# 1984 - 1986 Corvette: Service Bulletin: Window Regulators - Replacement

**Number:** REISSUE 86-17

**Subject:** WINDOW REGULATORS

**Model and Year:** 1984-1986 CORVETTE

### WINDOW REGULATOR ASSEMBLY

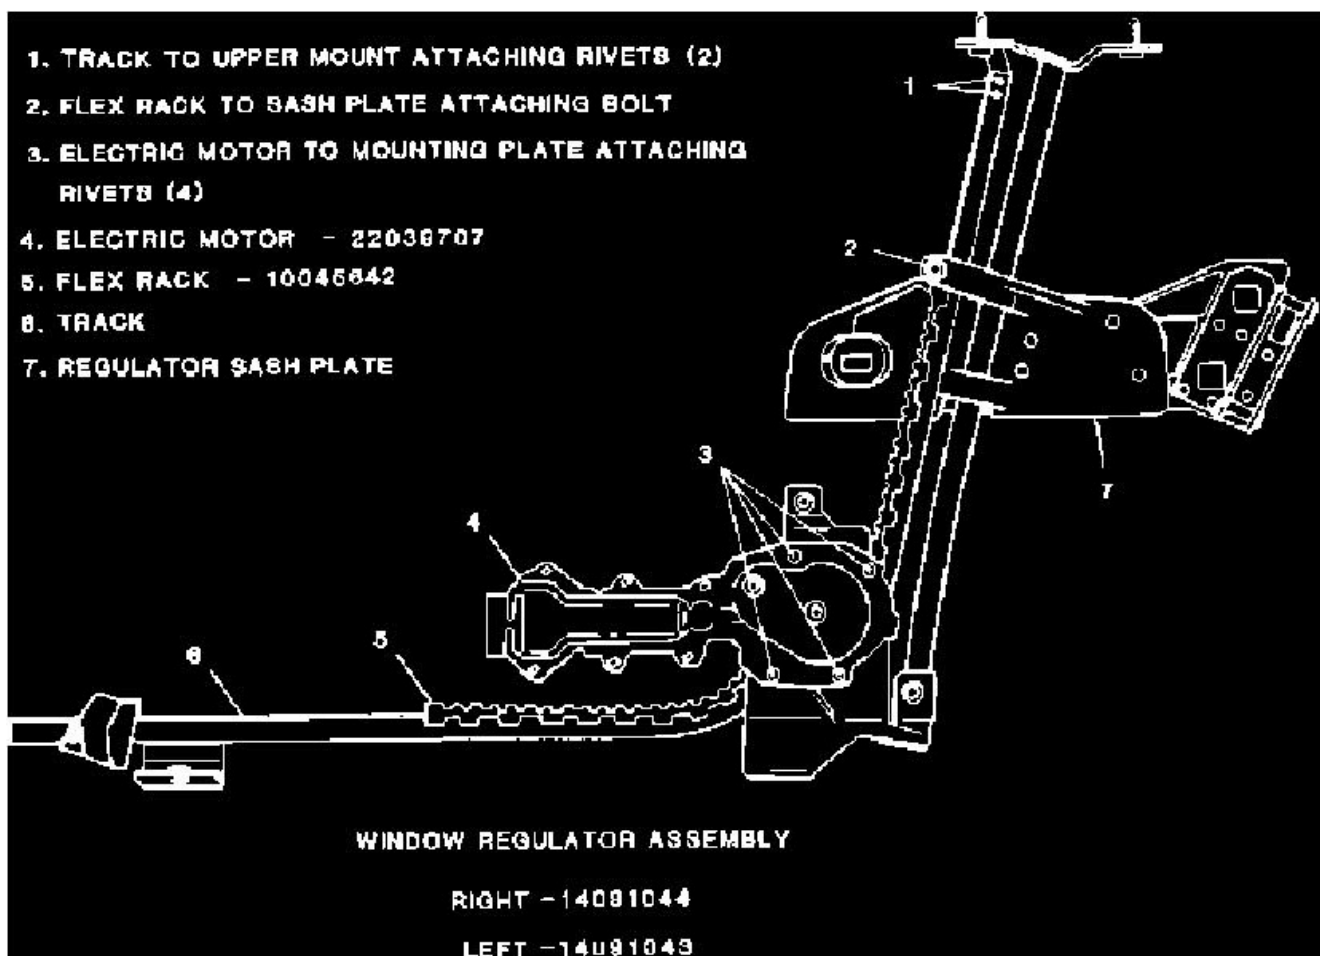
Conditions which in the past required complete window regulator replacements on Corvettes, can now be repaired by either replacing the complete regulator or servicing the existing regulator with component parts.

This bulletin contains part numbers and procedures for the replacement of the electric motor and plastic flex rack of the window regulator assembly (Items 4 and 5, Figure 1).

Regulator conditions encountered on vehicles built prior to September, 1984 or that have flex rack tracks which are not chrome, (Item 6, Figure 1) but are yellow or gold in color, or dull metal finish, require replacement of complete regulator assembly.

Conditions encountered on vehicles built after August, 1984 or regulators with chrome flex rack tracks (Item 6, Figure 1) may be repaired with component parts (electric motors and or revised flex racks, Items 4 and 5,

Figure 1).

1. Remove regulator assembly from door and place on a clean work surface.
2. Using an electric drill. motor and 4mm (5/32") drill bit, drill out four (4) attaching rivets that retain the electric window motor to the 1986 Chevrolet Corvette V8-350 5.7L Copyright © 2006, ALLDATA 8.80 Page 2 lower mounting place (location 3, Figure 1).

3. Remove the motor from the regulator assembly and transfer the plastic drive gear to the new motor.
4. Clean the lower mounting plate of all metal shavings prior to motor installation.

5. Apply lubricant (GM P/N 1052349 or equivalent) to the drive gear, flex rack, track and gear housing on the lower mounting plate.
6. Install the new motor to the mounting plate using four (4) 4 mm X 10 mm (5/32" X 3/8") rivets (location 3, Figure 1).

2. Using an electric drill motor and 4mm (5/32") drill bit, drill out the two (2) track to upper mounting plate attaching rivets (location 1, Figure 1).

3. Remove the Allen head type bolt (location 2, Figure 1) retaining the flex rack to the regulator sash plate. It will be necessary to hold the attachment nut on the underside of the sash plate to prevent it from rotating.

4. Lift track away from upper mounting plate and carefully pull track away from guide tube in order to disengage the flex rack and track from the sash plate opening at location 2, Figure 1.

9. Locate the flex rack and track into the sash plate opening at location 2, Figure 1. Apply Loctite Thread Sealer to the bolt threads prior to reinstalling the Allen type bolt at location 2, Figure 1 to prevent loosening from vibration.

10. Locate and fasten track to the upper mounting plate using two (2) 4mm X 10mm (5/32" X 3/8") rivets (location 1, Figure 1).
11. Using an external power source, operate the regulator to insure quiet, free operation.
